Recall Information Bulletin

No: C10131 Issued: 1/17/2025

Safety Recall C10131 – Vehicle Control Unit Circuit

FEC7K (E16L/E16M), FEC9K (E18L/E18M)

Step-5 :

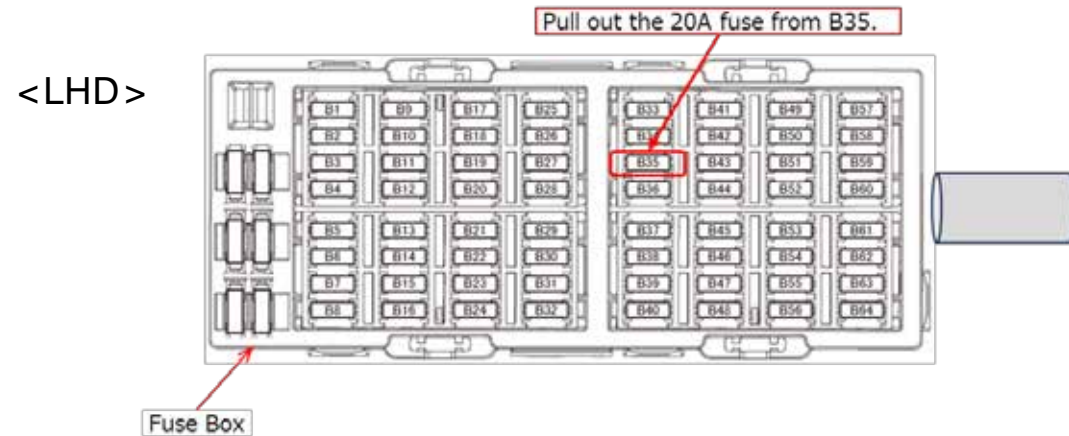
Remove the 20A fuse from B35 in the fuse box.

Step-6 :

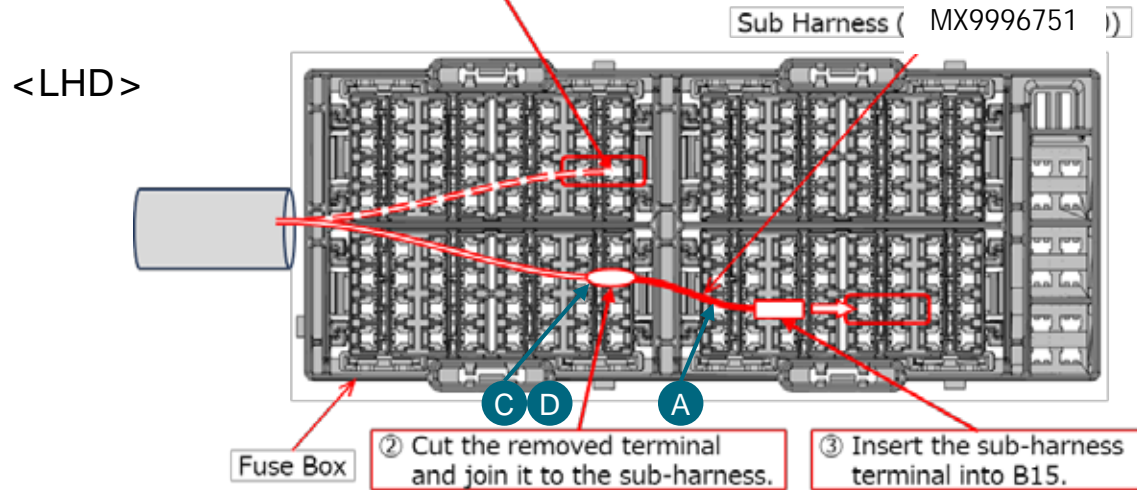
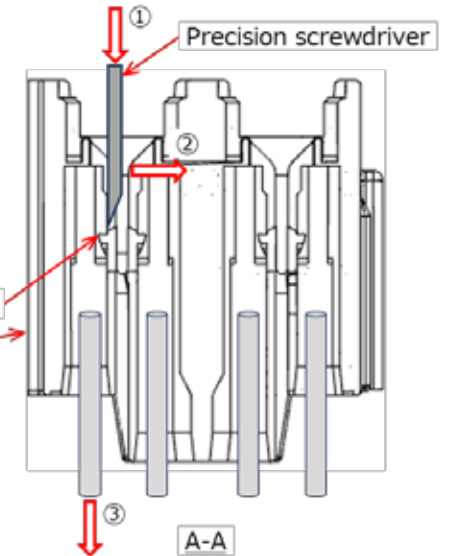
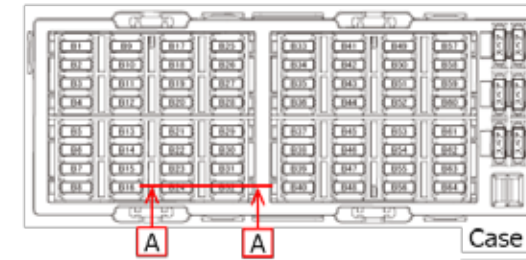
Remove the terminal (W/R) from B35 in the fuse box and connect to B15.

(Only LHD : use the sub-harness to extend harness to B15)

① Pull out the terminal (W/R) from B35.

Step-7 :

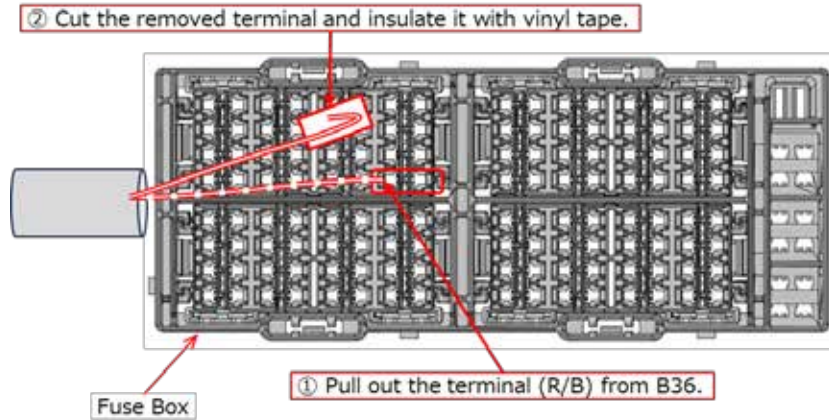
Remove the terminal (R/B) from B36 in the fuse box, cut the terminal, and insulate it with vinyl tape.

Step-8 :

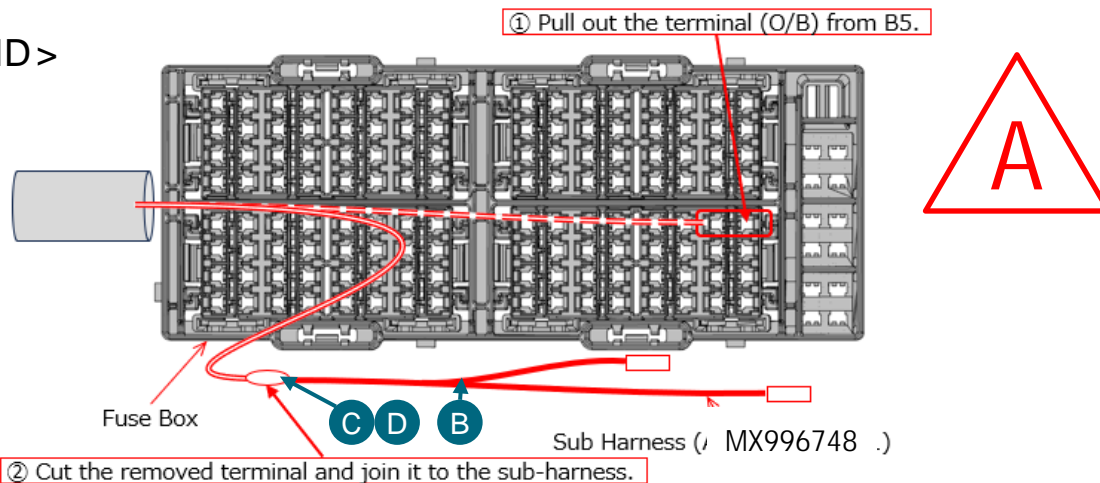
Remove the terminal (O/B) from B5, cut the terminal, and connect it to the sub-harness.

Step-9 :

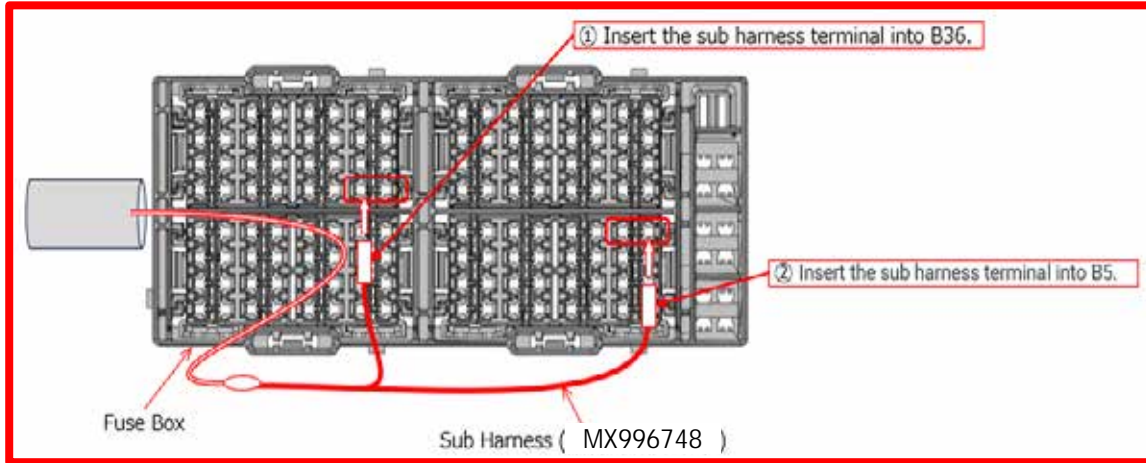
Insert the sub harness terminals into B36 and B5 of the fuse box.

Step-10 :

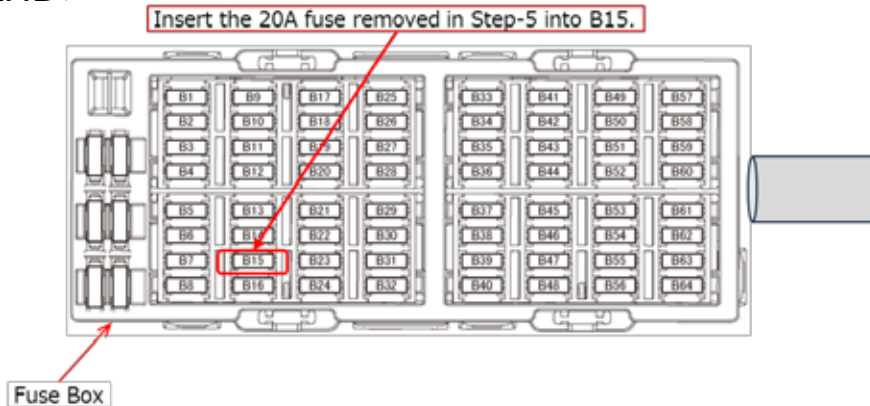
Insert a 20A fuse into B15 in the fuse box.

Step-13 :

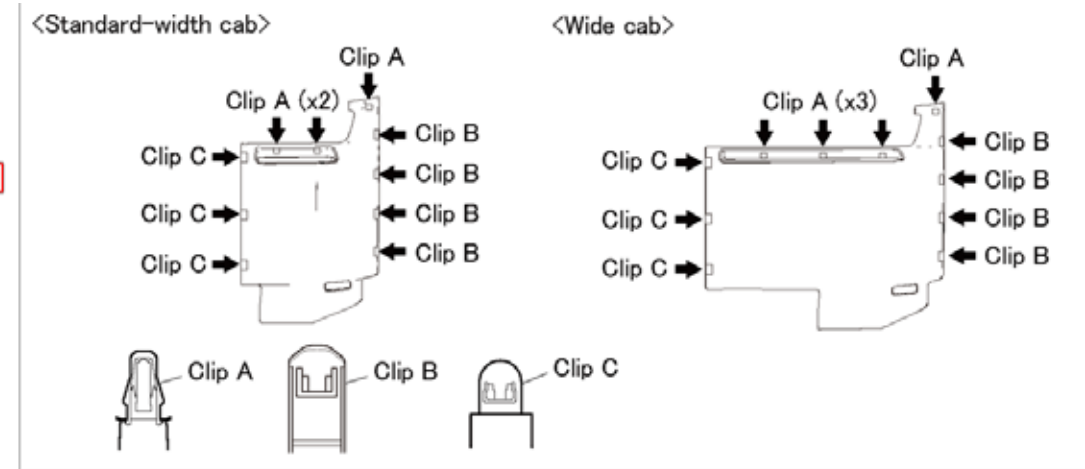
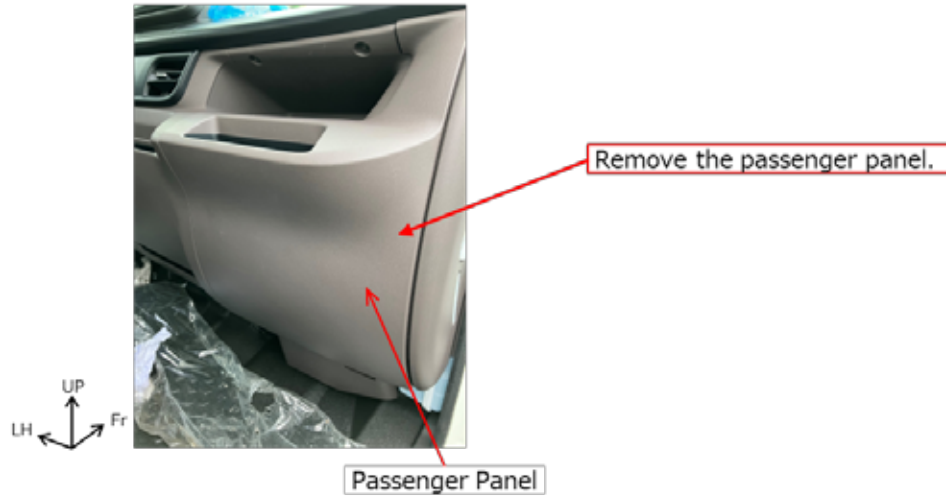
Remove the fuse information label (MX995730) from the back of the passenger side panel that was removed in step-2 and paste the countermeasure parts.

Peel off the fuse label and paste the countermeasure parts.
